URGENT - Field Safety Notification Medical Device Correction

Philips HeartStart MRx Monitor/Defibrillator on exceptionally rare occasions may exhibit abnormal behavior when operating using a single battery as the sole source of power.

Figure C: AC Module Removal

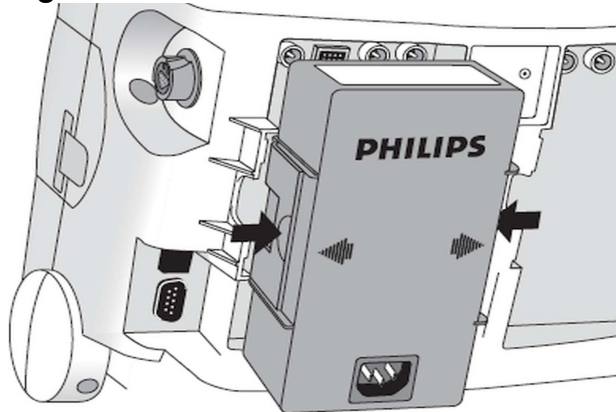
There are two ways to prevent this power switching. The user can either:

- a. Remove the AC module from the MRx, rather than unplugging the cord from AC mains (see Figure C).

- b. Turn on the MRx using the rotary knob and allow it to complete the start-up before unplugging the device from AC mains.
